TP File: 10529
File No: PDT-13-1
Applicant/Owner: Oakleigh Meadow LLC
Site Location: East end of Oakleigh Lane
Map & Tax Lots: 17-04-24-13-00400 & 17-04-24-24-05500

Proposal: Planned Unit Development (PUD) of approximately 2.3 acres. Proposes "Cohousing" with 28 one and two-story dwellings in a total of 7 buildings of 2 to 5 units each plus one two-story common building serving all residents. The said PUD proposal is known as Oakleigh Meadow Cohousing.

Appeal of Oakleigh Meadows PUD (PDT 13-1)

Landscaping Plan (PH-69)

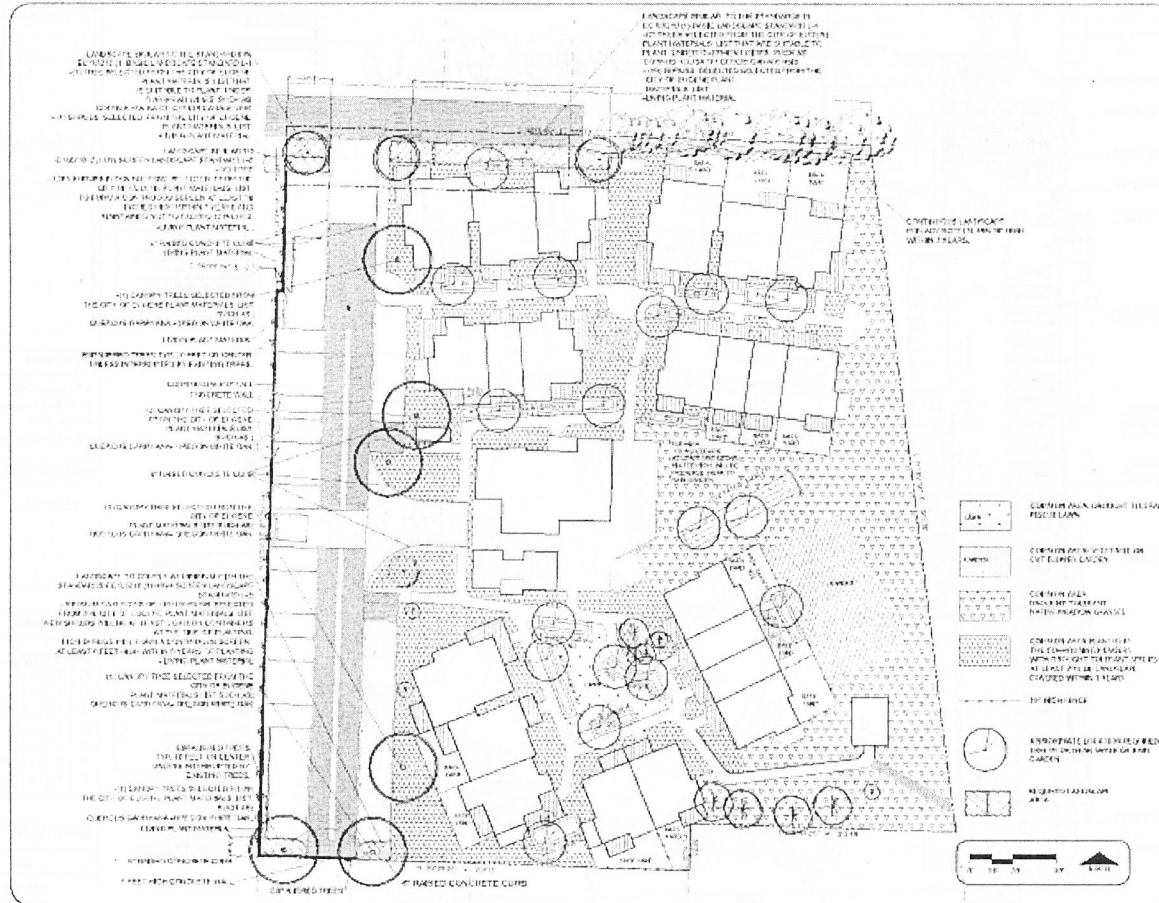
The PC finds that the applicant's proposed landscape plan (Sheet L2 of Exhibit PH-69) cannot be accomplished with the required right-of-way dedication, as there is no future guarantee that it would not be removed upon future street improvements. The HO did not specifically address this conflict in finding that the screening along the north property line would be sufficient to meet the approval criteria. Further, the right-of-way dedications along the north line result in the abutting buildings being too close to the future street, hammerhead, and access way improvements. For compatibility and safety purposes, the PC finds that adequate screening should be provided within the expanded setback areas along the north property line, therefore ensuring the continued existence of the required screening regardless of the timing for future street improvements.

- The final PUD plans shall show landscaping along the north property line consistent with the applicant's proposed landscape plan (Sheet L2 of Exhibit PH-69), but moved south within the required 5-foot setback outside of the newly dedicated right-of-way for Oakleigh Lane. The applicant shall also revise the site plans to show landscaping that meets the City's L-2 standard at EC 9.6210, within the required 10-foot setback along the remainder of the north property
